工程指示 / 要求簡箋(E.I.)

工程指示編號：EI / 3533 / 21

工程名稱：亞皆老街中電

工程項目：佛沙窗 地盤用玻璃 B.M. 大貨 (T1-T3: 22-23/F) (32 件)

22W4/ TIA

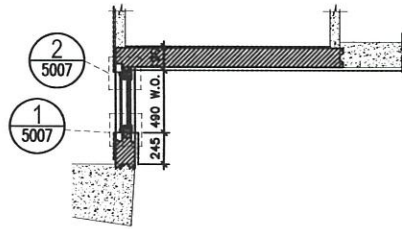
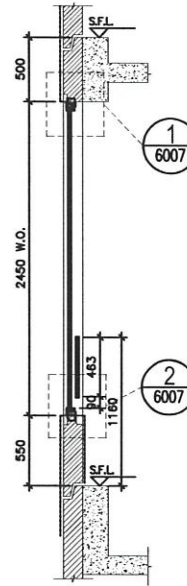
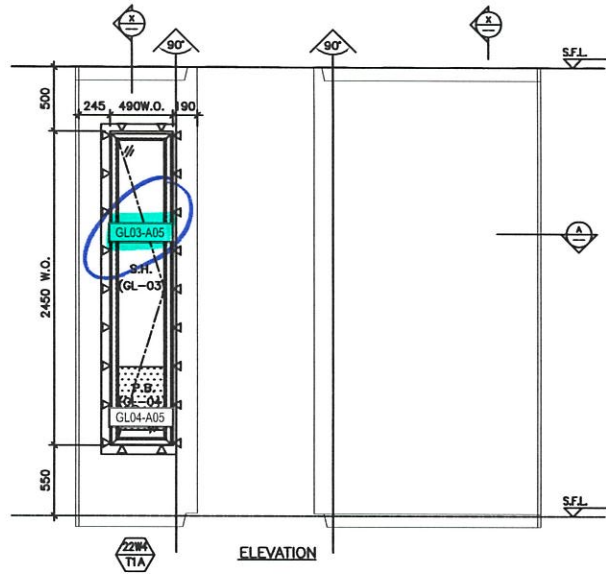
A 版：則師要求修改磨沙玻璃位置。請按 BM 訂購 T1-T3: 22-23/F 磨砂玻璃 (共 32 件)。

佛沙窗 磨砂玻璃位置

原有磨砂玻璃 (E13533)

新增磨砂玻璃 (E13533A)

|  美特鋁質 有限公司 MIDI Aluminium Fabricator Ltd. | | 工程號: J852 地盤名稱: | 計算: sde 核對: | 日期: 2021.02.20 日期: | 送呈: 副本: | 計算參考數值/所屬位置分格 | | | | | | | | | | | | | | 玻璃派窗表 | | |
|--|---------|---|---|------------------------------------|------------|---------------|-------|----------|-----------|----|----|------|-----|---------|---------|-----------|---------|---------|-----------|-------|-----|----|
| | A-新增/磨砂 | GL03-A05 | 6mm Low Iron Low E HS+12A+6mm Low Iron #3 acid etched (D21041725) Low-E: 6SEE0-83T | 24.0 | 385.0 | 2345.0 | 1 | 0.90 | 22W4/T1A | T1 | A | 生窗 | 22F | 490.00 | 361.00 | 385.00 | 2450.00 | 2321.00 | 2345.00 | 1 | | 1 |

23th FLOOR PLAN
 (SHEET 1)

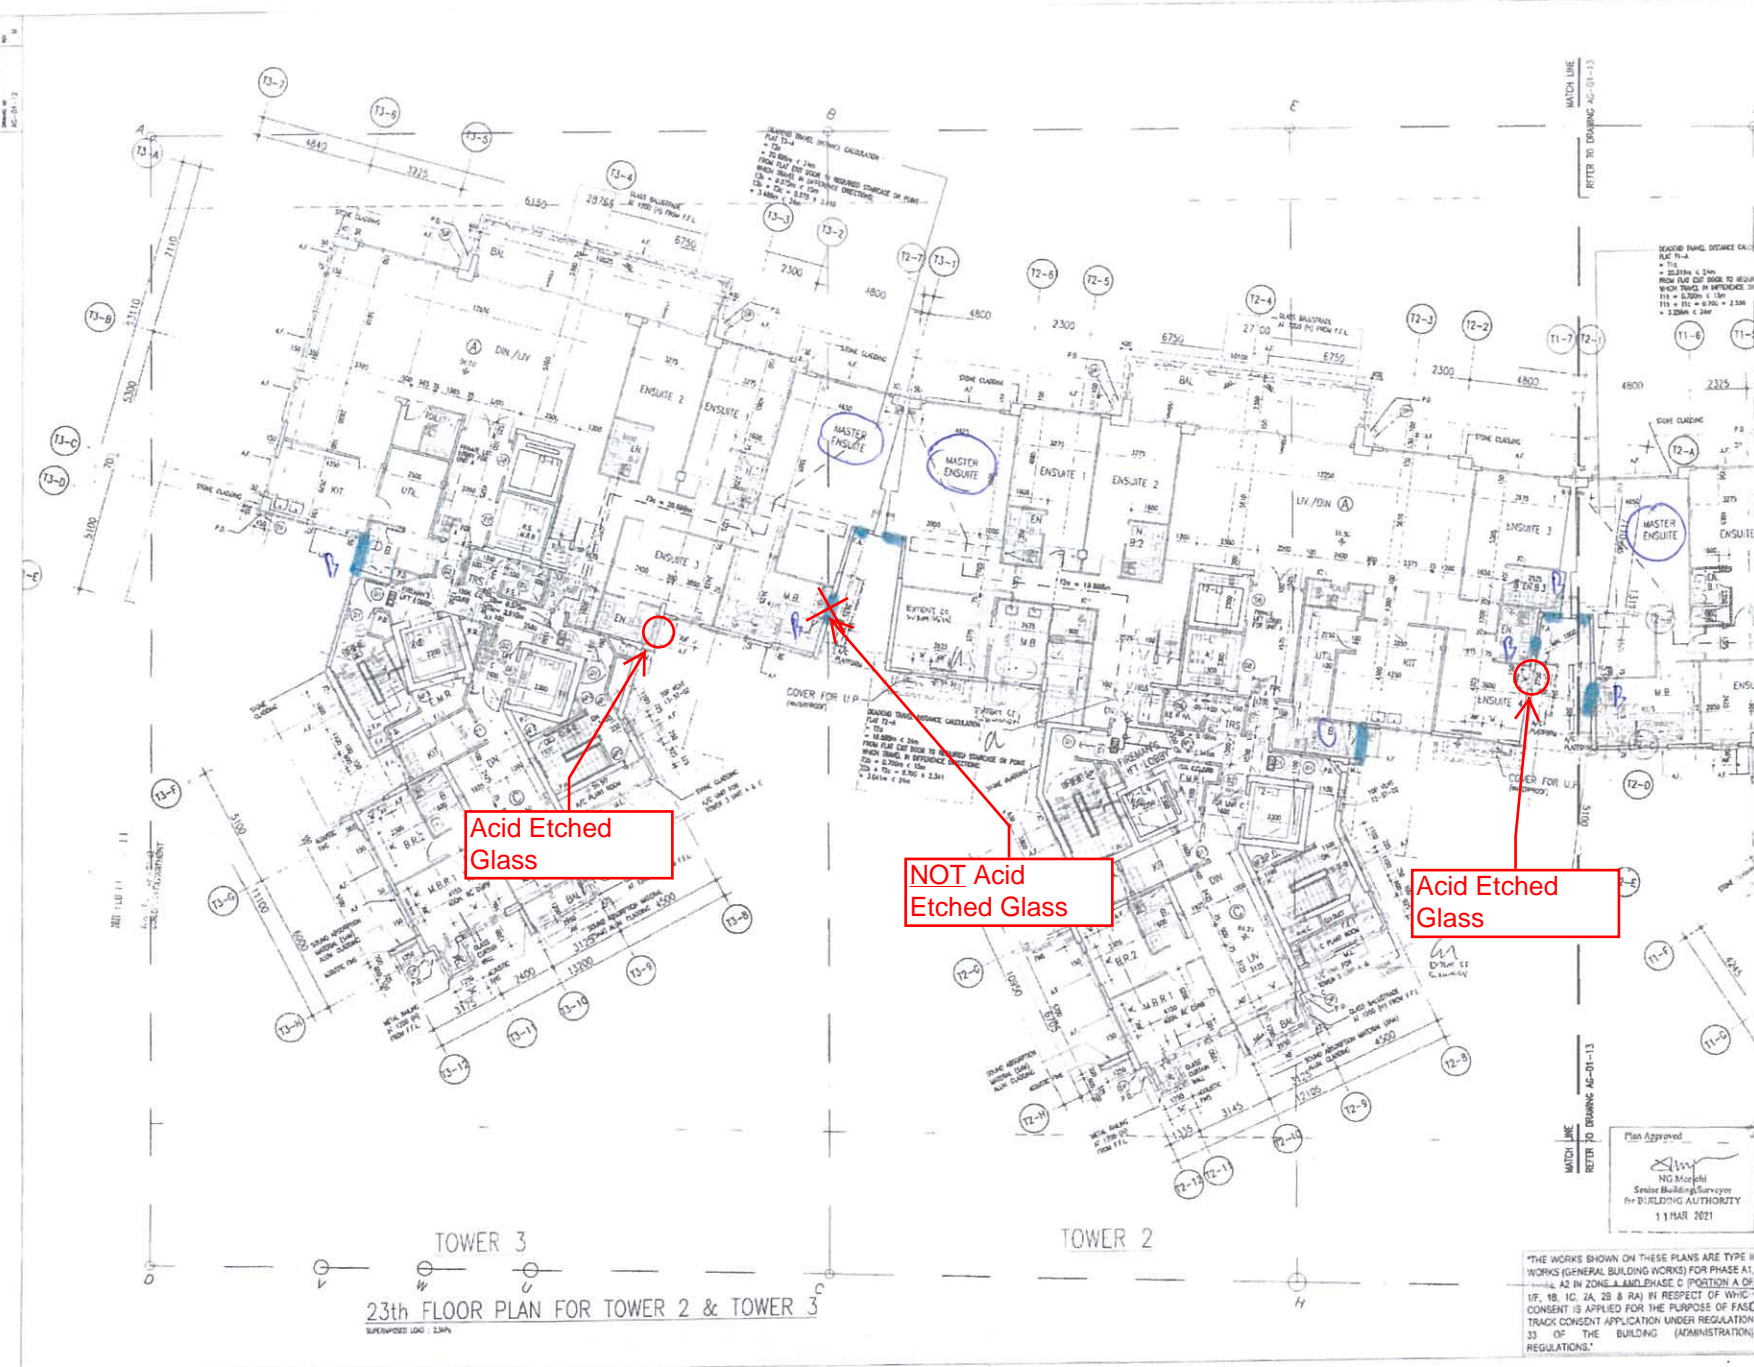
Please note that the location plan of acid etched glass to be used attached in your submission is INCORRECT. Please refer to attached markup for your further action. An updated location plan shall be attached to this submission for our approval.

Acid Etched Glass
